# NOTICE OF DECISION

**CLASS 3 SITE PLAN REVIEW / CLASS 2 ADJUSTMENT**  
**CASE NO.: SPR-ADJ23-16**

**SUMMARY:** Site and building upgrades for an new daycare facility

**LOCATION:** 1205 Wallace Rd NW, Salem OR 97304

1 Site Plan - Proposed

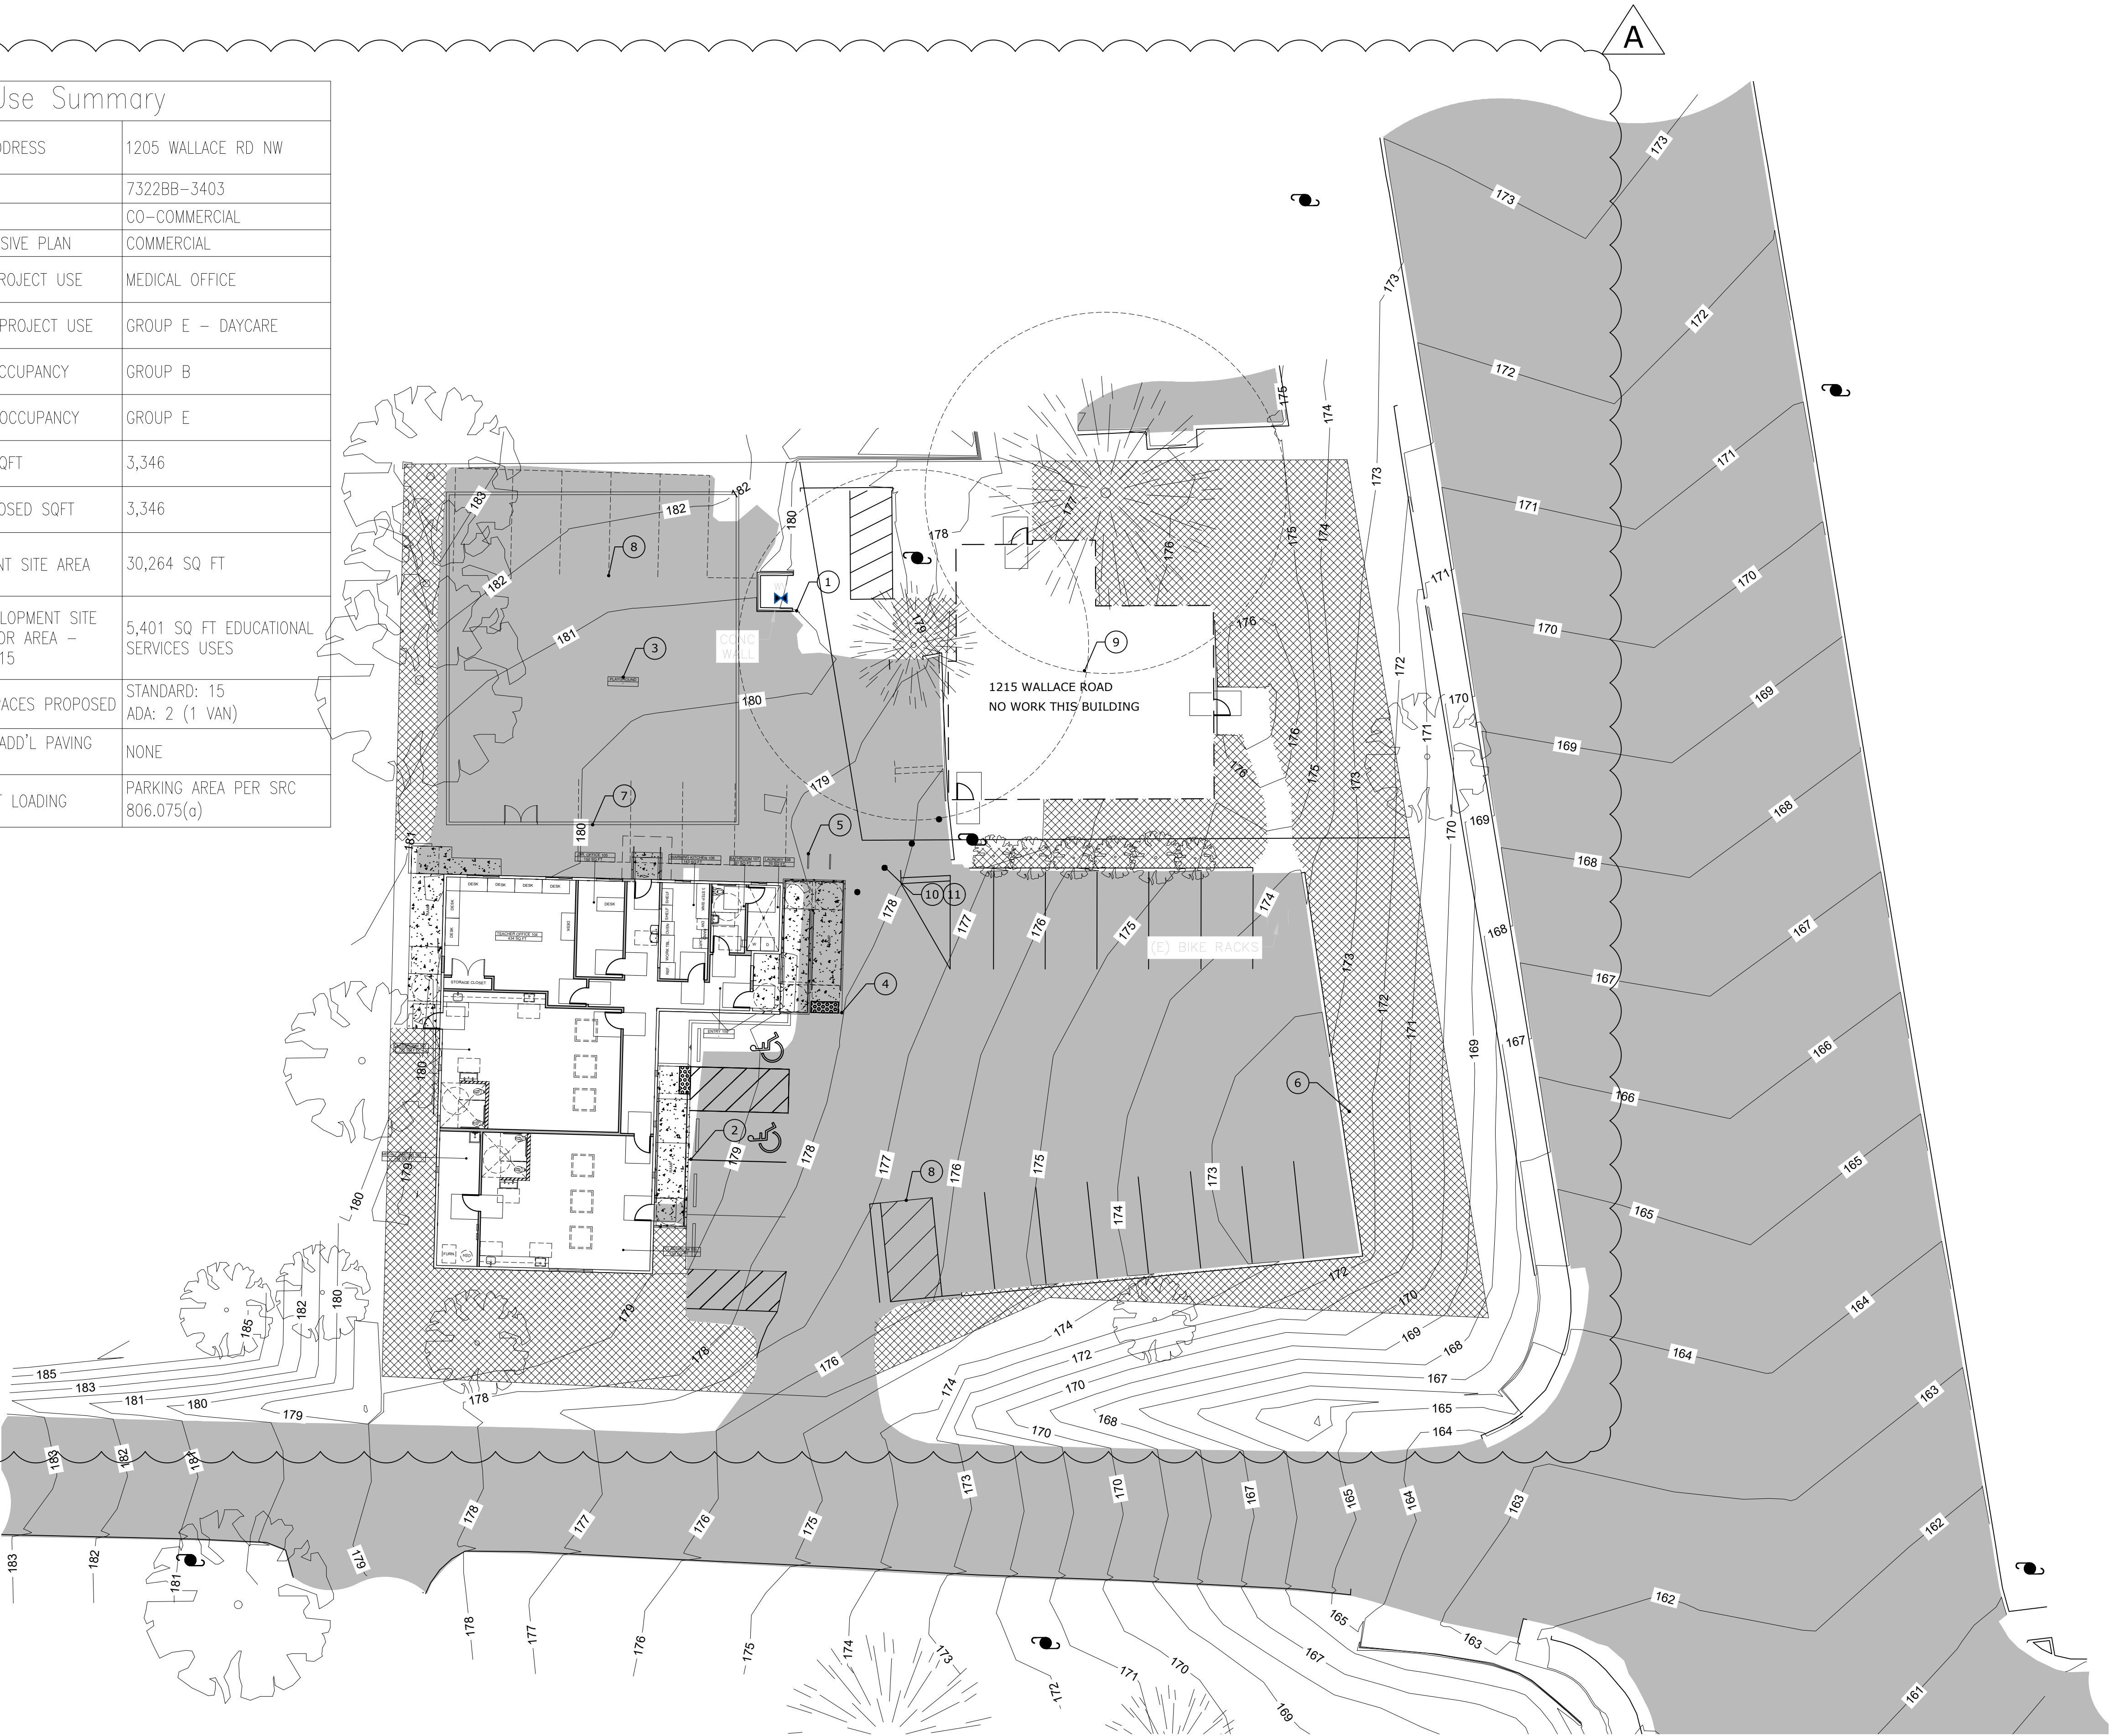
**Condition 3:** The striped area labeled as note eight on the site plan shall be removed, and all existing striping in this area shall be removed in order to ensure that a drive aisle meeting the standards of SRC 806.035(e).

**Finding:** As shown on the site plan, the proposed development includes one drive aisle that terminates in a dead-end. The turnaround for this dead end is existing and is not proposed to be reconfigured. This standard is not applicable to the proposed development.

**Finding:** Table 806-9 specifies that four bicycle parking spaces are required for a day care use. The proposed site plan shows four new bicycle parking spaces in addition to the four existing bicycle parking spaces on the site. This requirement is met.

**Finding:** The site plan indicates inverted style bike racks will be provided. The proposed bike racks conform to material requirements of SRC 806.060(e).

**Finding:** The site plan indicates 7,865 square feet of existing landscaped area is proposed to remain, requiring a minimum of 393 plant units ( $7,865 / 20 = 393.25$ ). Of the required plant units, a minimum of 157 plant units shall be trees ( $393 \times 0.4 = 157.3$ ). The applicant's site plan shows existing landscaping, some of which will need to be removed in order to accommodate pedestrian connections, as conditioned in this decision. As such, the following condition applies:

**Finding:** There are two significant trees identified on the subject property: a 32-inch DBH Cedar and a 33-inch DBH Fir tree. The applicant’s site plan shows that the critical root zones for these trees will not be disturbed by the proposed development. However, as conditioned in this plan, pedestrian connections will be required between buildings on the site and connecting to Wallace Road NW. In order to ensure that critical root zones will be protected, the following condition applies:

**Condition 3:** The striped area labeled as note eight on the site plan shall be removed, and all existing striping this this area shall be removed in order to ensure that a drive aisle meeting the standards of SRC 806.035(e).

**Condition 4:** At the time of building permit review, the applicant shall show detailed plans for bicycle racks to ensure compliance with the standards of SRC 800.060(c).

**Condition 5:** At the time of building permit review, the applicant shall provide a full landscape plan demonstrating how the development site meets Type A landscaping, including all new and existing landscaped areas, by providing a minimum of one plant unit per 20 square feet of landscaped area, with 40 percent of the plant units being trees.
